Rezoning Transportation Analysis

Petition Number: 2022-134

Date	Description
01-26-23	First Review (PDM)
02-22-23	Second Review (JP)

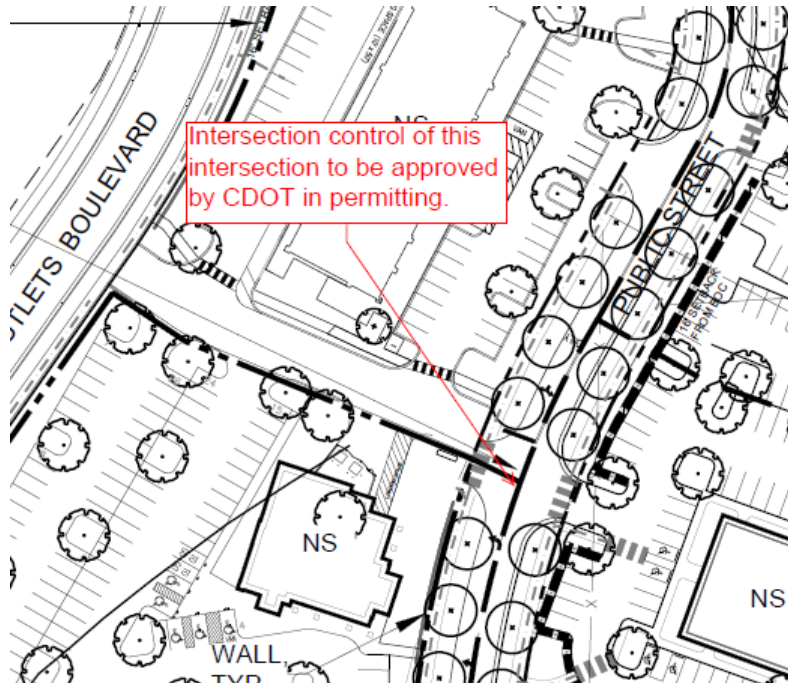
3. Add callout and conditional note for the proposed intersection control to be approved by CDOT during permitting for the below intersection.

Clarifying Comment from 2-22-23: Add conditional note and callout
